**Si3402-A-GM to Si3402-B-GM EVB Modifications
Version 0.4**

The Si3402-B-GM device requires component value changes from those used with the Si3402-A-GM evaluation board (EVB) reference design. Table 1 below is a summary of the required modifications.

Si3402ISO (Flyback, Isolated) EVB Reference Design – 5V

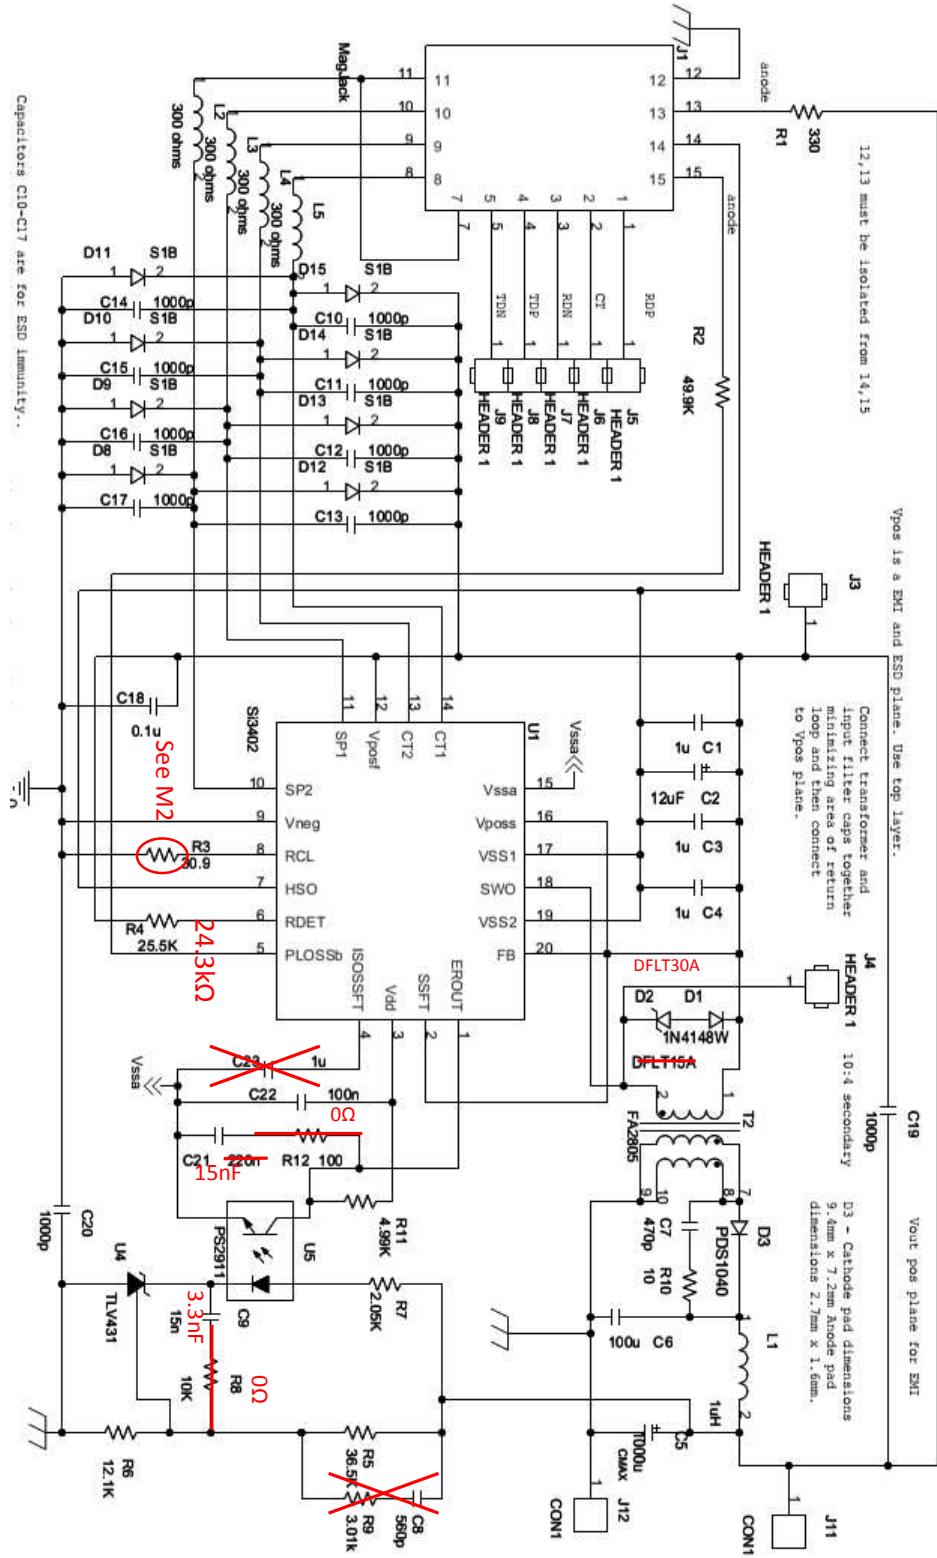
Following Table 1 are two reference schematic excerpts showing the locations of the modified component values for both the isolated (flyback) and non-isolated (buck) topologies.

Item	Modification description	Application design effect
M1	Detect resistor value change	The former 25.5kΩ detect resistor must be replaced by 24.3kΩ 1%
M2	Classification resistor value change	The following 1% resistors must be used: Class0: 681.00 or higher (It is optional to place this resistor) Class1: 140.0 Class2: 75.0 Class3: 48.7 Class4: 33.2
M3*	ISO EVB DCDC 3.3V changes Flyback	C8, R9 & C23 are not need—Do not populate them. C9=10nF, C21=33nF, R12=475 Ω & R8=1.1k Ω Replace D2 (DFLT15A) with DFLT30A * See Revision Notes
M4	ISO EVB DCDC 5V changes Flyback	C8, R9 & C23 are not need—Do not populate them. C9=3.3nF, C21=15nF, R12=0 & R8=0 (place zero Ω resistors) Replace D2 (DFLT15A) with DFLT30A
M5	ISO EVB DCDC 12V changes Flyback	C8, R9 & C23 are not need—Do not populate them. C9=10nF, C21=15nF, R12=0, R8=0 (place zero Ω resistor) R7=3k Replace D2 (DFLT15A) with DFLT30A
M6	DCDC reference voltage change (Buck case only)	Now 1.35V instead of previous 1.23V. Thus, R5 changes from 2.87kΩ 1% to 3.24kΩ 1%. R6 (1%) is modified according to this table:

Vout Target	R5 kΩ	R6 kΩ	Vref	Vout Measured
		3.3	3.24	4.64	1.35	3.37
		5	3.24	8.66	1.35	4.96
		9	3.24	18.2	1.35	8.93
		12	3.24	25.5	1.35	11.98
M7	BUCK EVB DCDC 3.3V compensation network changes	C19, C20 & C9 are not need—Do not populate them. R8 can be populated with a 0Ω resistor (creating a short between pins 3 and 4) or left unpopulated, since the ISOSSFT function is now internal (see datasheet). C7=1nF, R7=47kΩ ±20%.				
M8	BUCK EVB DCDC 5V compensation network changes	C19, C20, R8 & C9 are not need—Do not populate them. R8 can be populated with a 0Ω resistor (creating a short between pins 3 and 4) or left unpopulated, since the ISOSSFT function is now internal (see datasheet). C7=1nF, R7=47kΩ ±20%.				
M9	BUCK EVB DCDC 12V compensation network changes	C19, C20, R8 & C9 are not need—Do not populate them. R8 can be populated with a 0Ω resistor (creating a short between pins 3 and 4) or left unpopulated, since the ISOSSFT function is now internal (see datasheet). C7=1nF, R7=47kΩ ±20%.
